UNITED STATES  
NUCLEAR REGULATORY COMMISSION

February 24, 2000

SUBJECT: USER NEED REQUEST ON THE ACCEPTABILITY OF THE  
ARRHENIUS METHODOLOGY FOR ENVIRONMENTAL  
QUALIFICATION (EQ) FOR LOCA AND POST-LOCA ENVIRONMENTS

Figure 1 - Conceptual Depiction of Activation Energy [4]

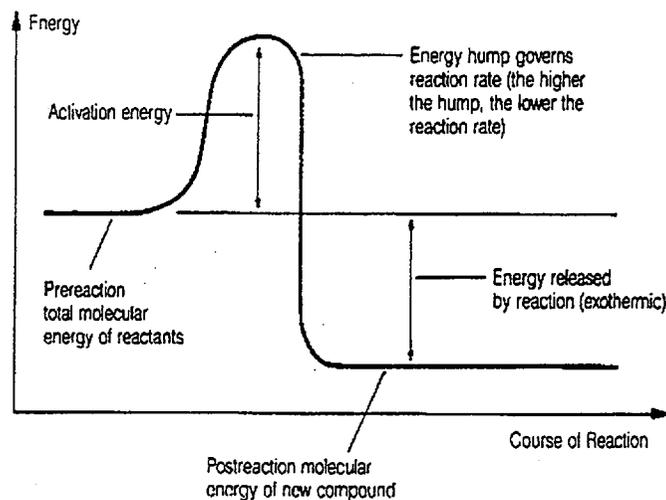
Figure 1 does represent the reaction pathway of an activated process, but the same remarks concerning relevance apply.

Figure 2 - Rockbestos Firewall III Accelerated Aging Test Data [24]

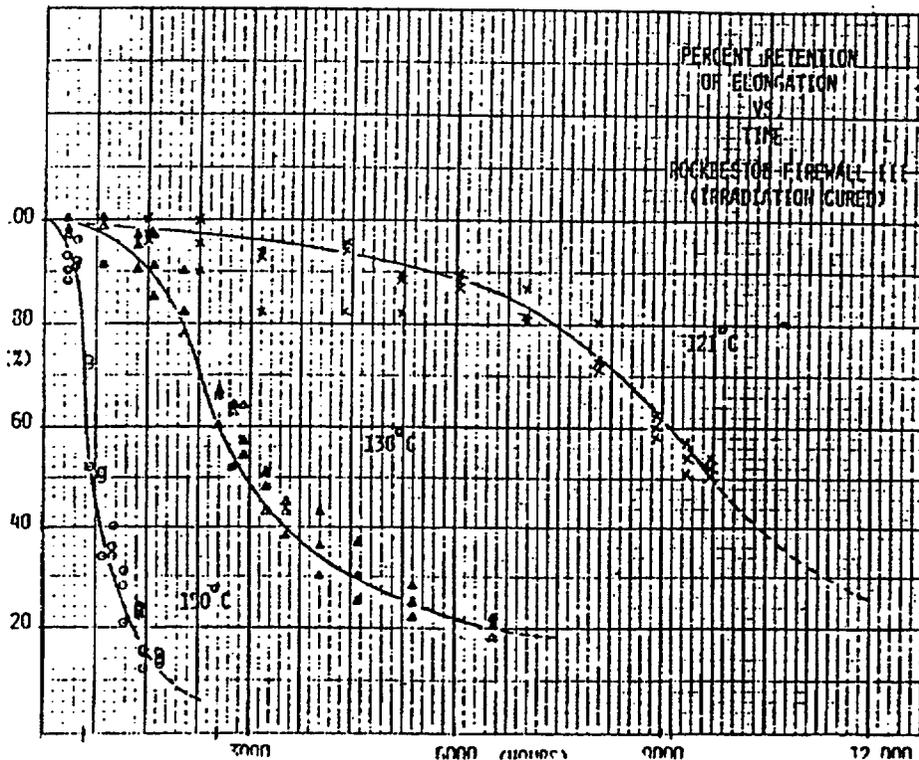
Figure 2 shows an aging test of a cable material at three temperatures. The entire property decay curve is given, based on roughly 30 observations per temperature. This looks like very thorough work. Figures 3-5 show similar information, but there are no data. All of these graphs should have used a log time scale to assess a very important point—the possible independence of time scaling on the degree of degradation. Time scaling is more general than Arrhenius; i.e., the time shift factors could follow any relationship, including the Arrhenius, WLF, Vogel-Fulcher, etc.. If the proper function for the time shift is the Arrhenius equation, then the reported activation energy would be independent of the end-point chosen. With parallel reaction routes, this is not expected, but the deviation appears to be slight. Empirically, the dependence has been reported to be large; for example, the activation energy for EPR changes from 1.28 to 1.05 eV if the end-of-life criterion is changed from 20% to 40 % loss of elongation [Carfagno and Gibson (1980)]. It should be noted that these numbers were from different studies.

Figure 6 – Life Curve for a Typical Motor Insulating System [30]

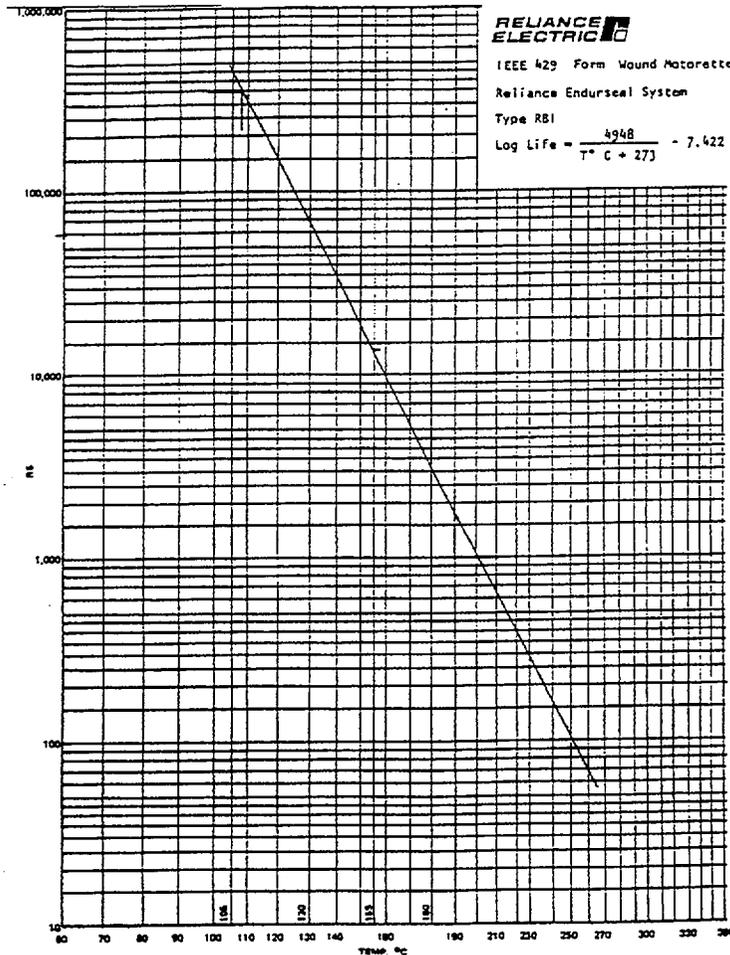
Figure 6 is typical schematic life curve. No data points are evident, so there is no possibility to test for curvature or determine the error associated with extrapolation. Thus this figure is illustrative only and contributes little to the argument.

Figure 7 - Degradation Trajectories for Varying Temperatures

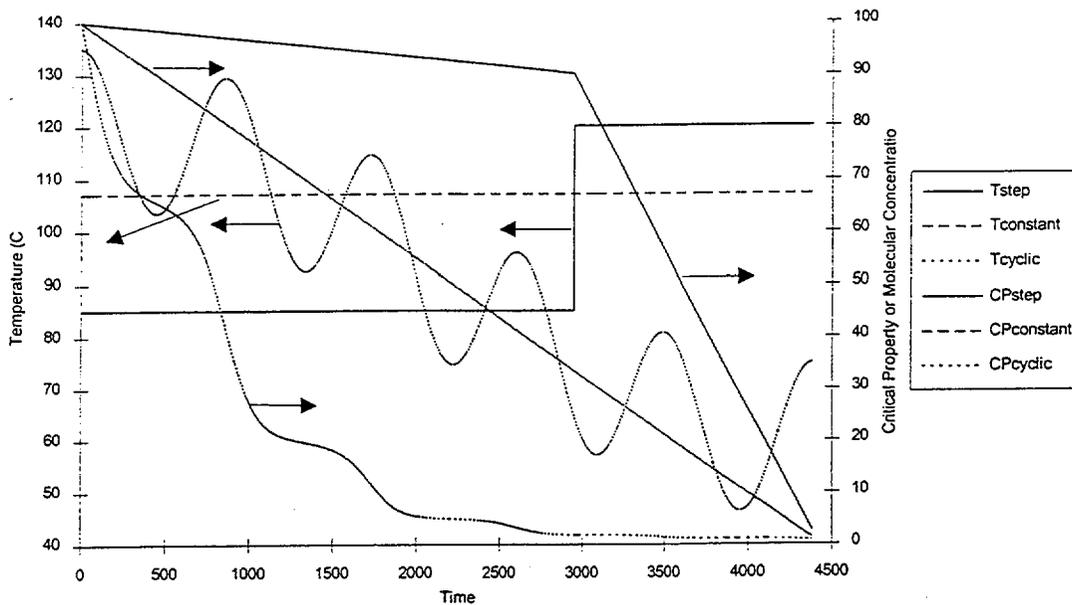
Figure 7 is a schematic showing possible  $T(t)$  paths. The discussion of this centers on the fact that the arithmetic average temperature will predict too little degradation. Figure 8 shows the corrections from a Sandia report. Presumably this figure is a plot of the well-known relationship for the Arrhenius-average temperature,  $T_{eq}$ , given by

Figure 9 - Superposition of Elongation Data [35]

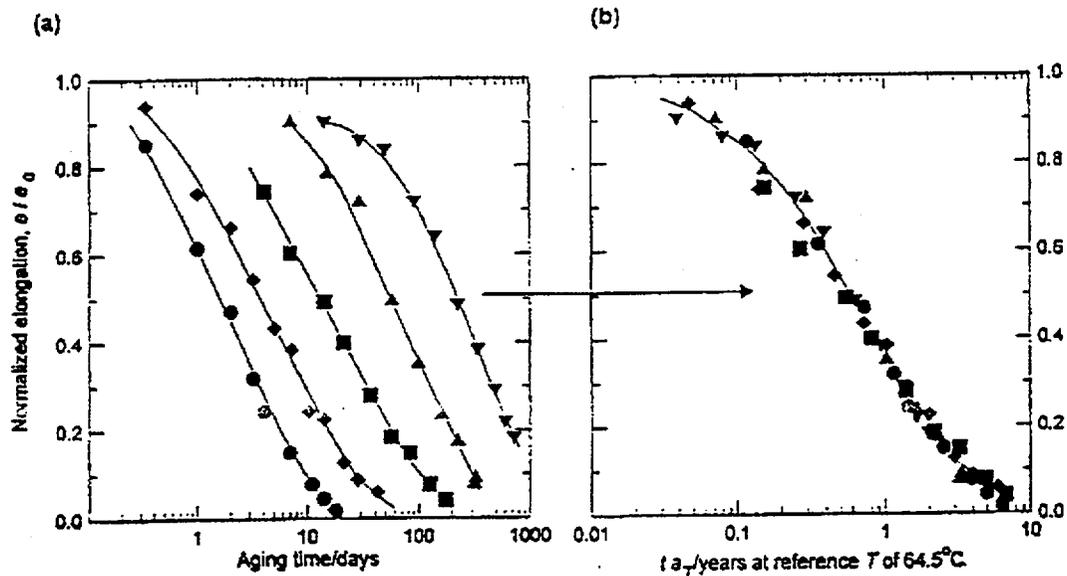
Fig. 9 addresses again the possibility that the activation energy is independent of the degree of degradation. Superposability of the elongation data suggests such independence, at least for this material (nitrile rubber). Clearly, more extensive investigations of this type are needed, covering a variety of materials and with carefully measured property decay curves. The reason this is important is that the results could provide a basis for condition monitoring, wherein slight degradation is used to predict the expected aging at longer times. In the discussion of this figure, the authors claim that Figure 3 of the report shows that the activation energy of Raychem WCSF increases as the degradation increases. Although Figure 3 doesn't support this claim, it is the logical direction as the easy degradation pathways will be used first. It is also commonly observed in thermogravimetric analysis of the pyrolysis of polymers [Cooney et al. (1984)]. The NUGEQ authors states that this trend is conservative, which relies heavily on the compensation principle. Answers to this question await investigation of aging along nonisothermal paths.

Figure 10 - JAERI EPR3 (EPR) Test Results

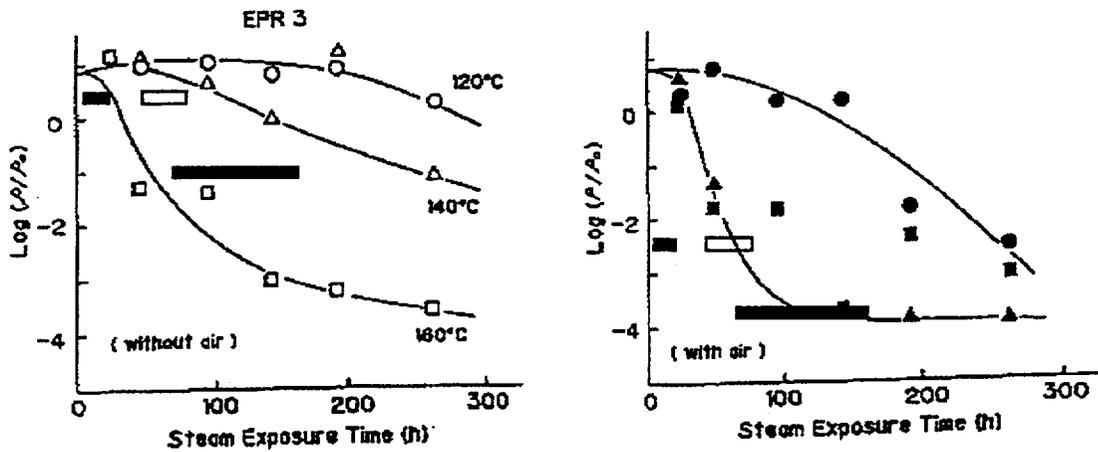
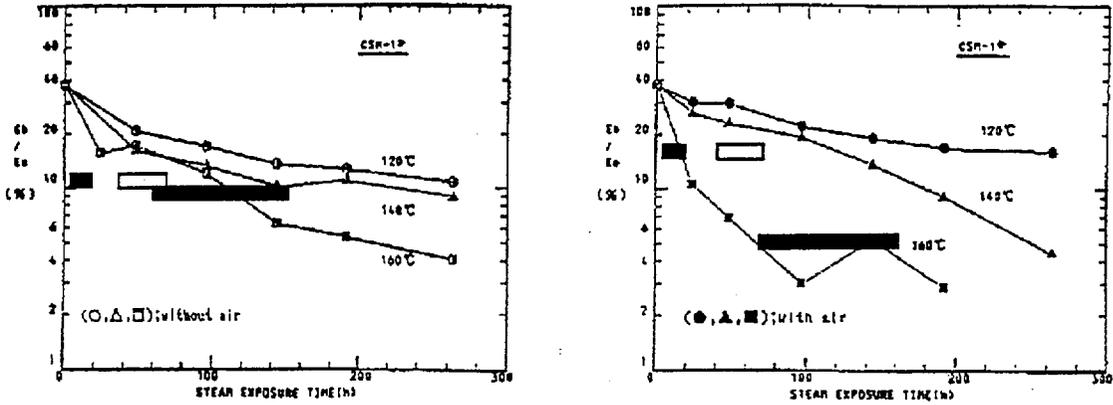
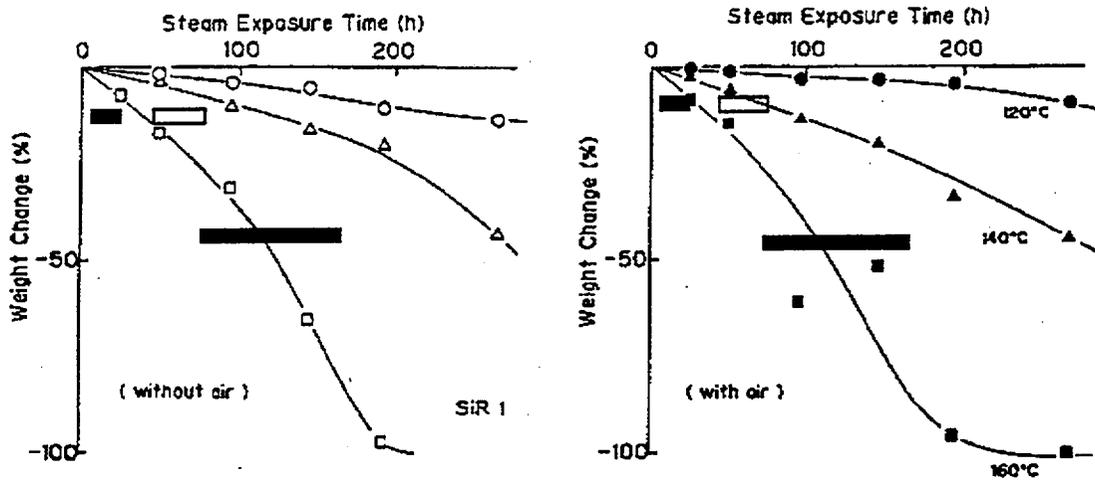
Figures 10-12 compare degradation in steam using atmospheres that include or exclude oxygen. To simulate LOCA conditions, the temperatures were high. The NUGEQ authors use this information to point out that steam is not a factor in spite of the clear difference between the property decay curves of Hypalon at 160 °C in Figure 11, and the fact that oxygen (air) concentration, and not steam, was the factor in this experiment.

Figure 13 - Saturation Pressure vs. Inverse Absolute Temperature

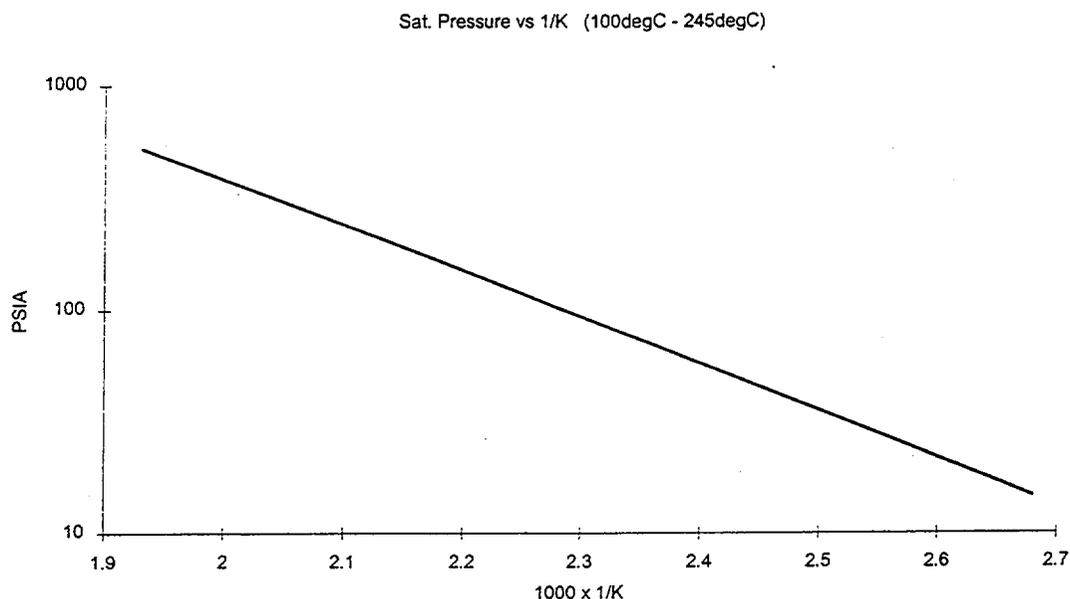
Figure 13 shows the vapor pressure of water and its Arrhenius form is used to argue that steam degradation is likely to be Arrhenius in form also. Aside from the fact that vapor pressure is not Arrhenius, but follows more closely the relationship

Figure 14 - Polyurethane Arrhenius Plot at Varying Relative Humidity

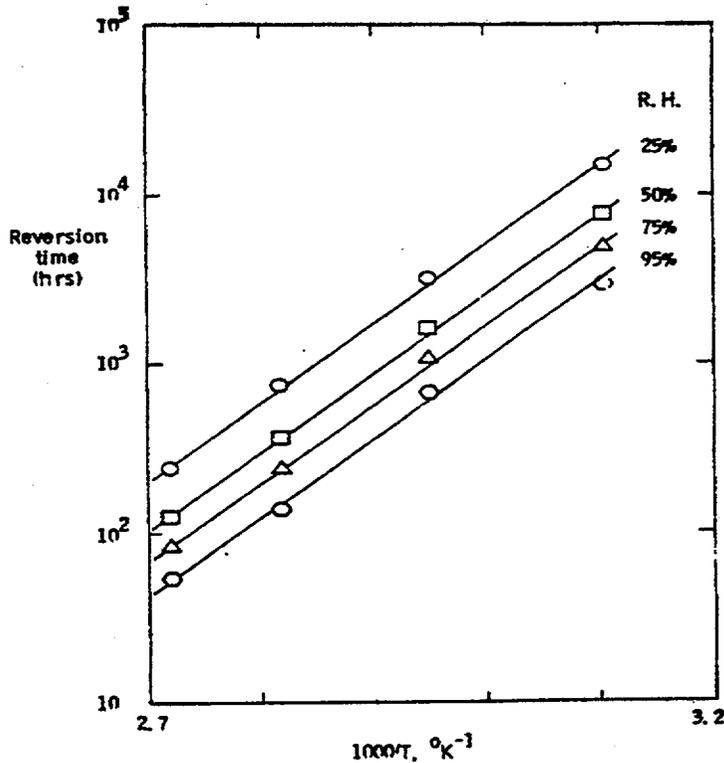
The discussion of Figure 14 is important. The NUGEQ authors use the Arrhenius behavior of polyurethane degradation in steam as an indicator that the Arrhenius method

Figure 15 - Terminal Block Leakage Current vs. Steam Temperature [42]

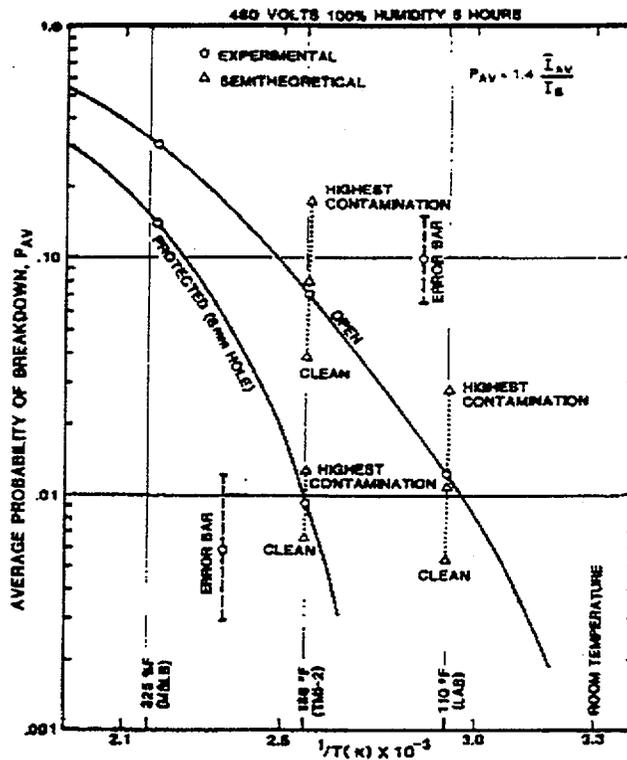
Figure 15 shows non-Arrhenius, but conservative, behavior of breakdown probability (cumulative probability over a fixed period of time?). Although the data are a bit sparse, this work tends to support the NUGEQ authors' contention that tests at lower temperatures would safely predict the behavior at higher temperatures.
